MONTGOMERY COUNTY HISTORIC PRESERVATION COMMISSION
STAFF REPORT

Address: 2 East Lenox Street, Chevy Chase **Meeting Date:** 3/23/2022
Resource: Outstanding Resource
(Chevy Chase Village Historic District) **Report Date:** 3/16/2022
Applicant: Marijke Jurgens Dupree
(Eric Morrison, Architect) **Public Notice:** 3/9/2022
Review: HAWP **Tax Credit:** N/A
Staff: Michael Kyne
Permit Number: 981893
PROPOSAL: Garage fenestration and door alterations, chimney alteration, roof replacement, and skylight installation

Fig. 3: House blueprint, showing the south (rear) elevation of the original garage.

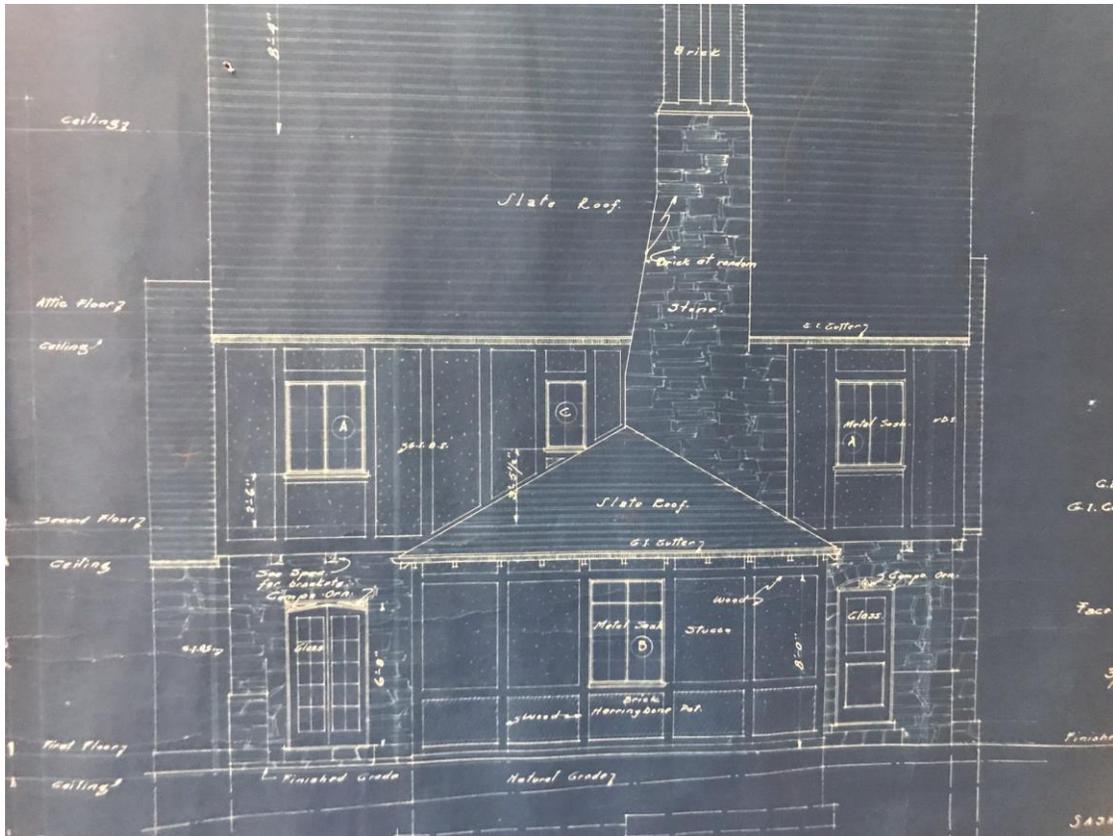
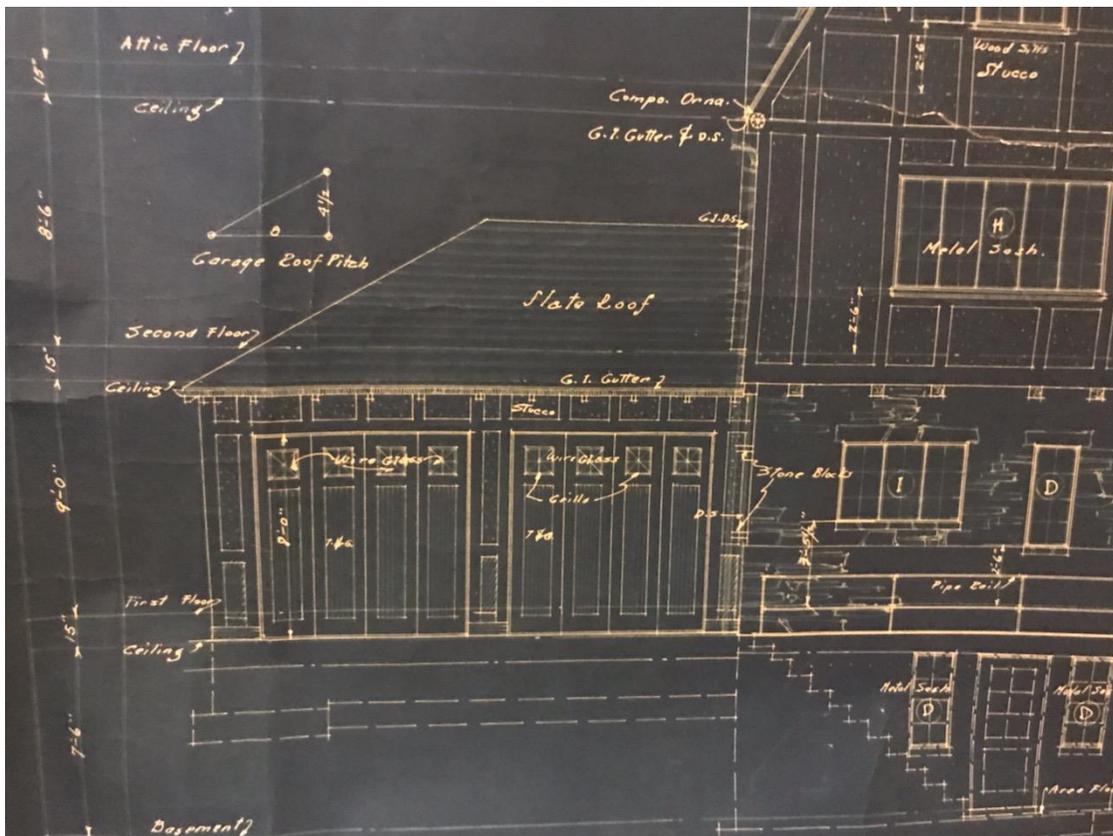
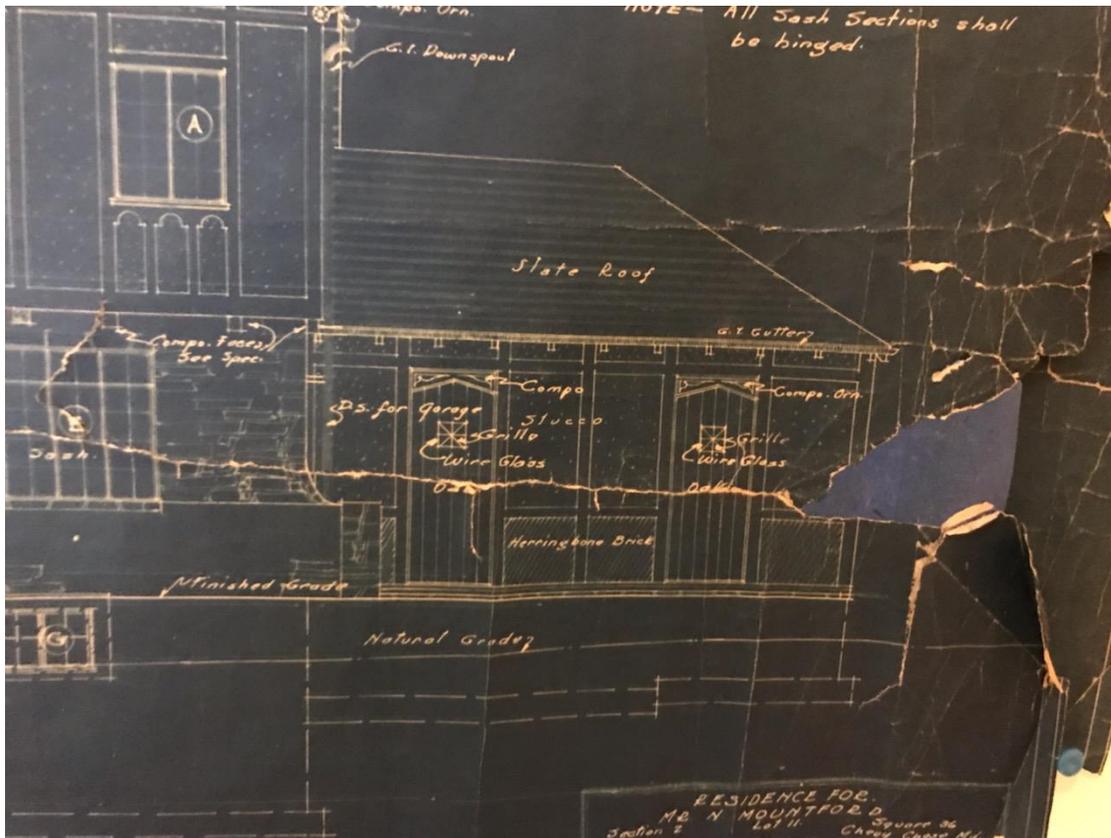
While the attached rear garage appears in the 1927 Sanborn Fire Insurance Map (*Fig. 2*), the original blueprints (*Figs. 3-5*) for the house demonstrate that it has been significantly altered (likely when it was converted to a family room). Notably, the original garage was constructed from timber framing and stucco, while it is currently clad in stone to match the first floor of the historic house. The garage has also been enlarged, and a covered porch has been added to the west (right, as viewed from the public right-of-way of East Lenox Street) elevation. Staff notes that the original roof pitch of the garage was steeper, as the ridge was not raised when the garage was enlarged. The existing chimney at the south side (rear) of the garage is not present in the original blueprints, and the original south (rear) fenestration has been

altered (i.e., there was originally a casement window where the chimney is now located, and the two windows flanking the chimney were later additions). The two original garage doors have been removed, and a centered sliding glass door has been installed on the east (left) elevation. The two original entry doors on the west (right) elevation have also been removed, with a centered sliding glass door added.

EAST ELEVATION

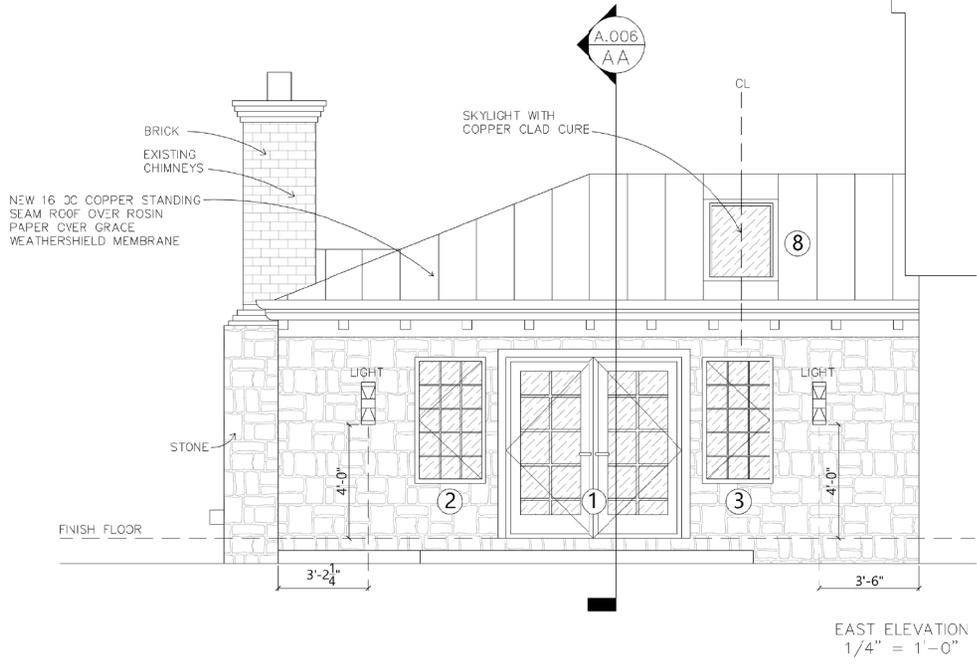
Staff finds that the proposed alterations on the east (left) elevation (and roof slope) of the garage will not be visible from the public right-of-way, while the proposed alterations on the south (rear) and west (right) elevations of the garage will be visible (those on the south (rear) elevation being minimally visible, at best), due to the property's location on a corner lot. However, staff fully supports the applicant's proposal, even when applying "Strict Scrutiny" to all proposed work items. The *Guidelines* state:

1- REPLACE DOOR
2- NEW WINDOWS WITH NEW OPENINGS

WEST ELEVATION

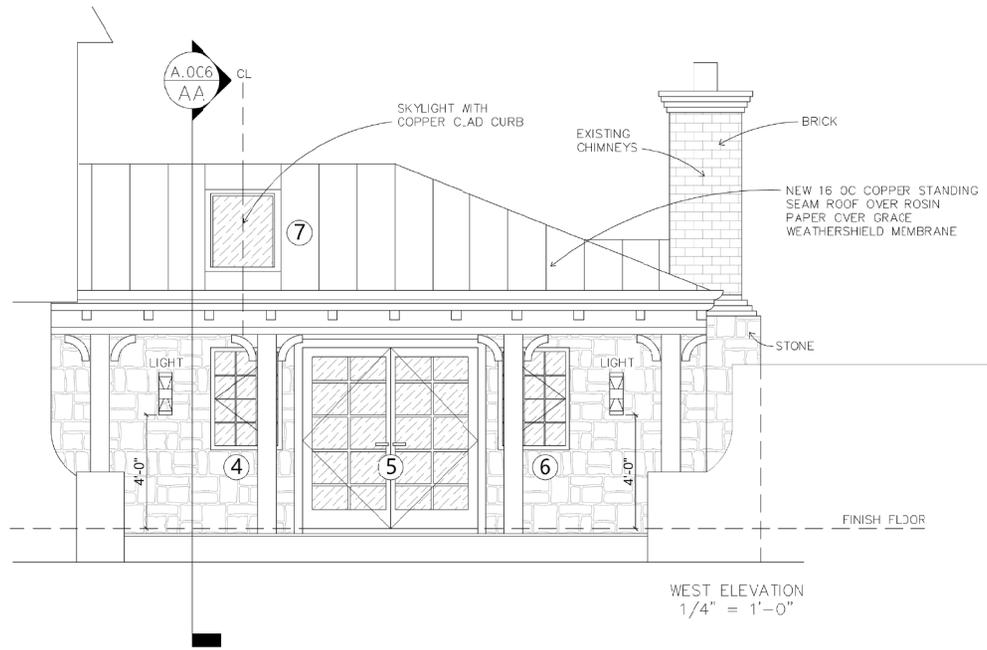
- 1- REPLACE DOOR
- 2- NEW WINDOWS WITH NEW OPENINGS
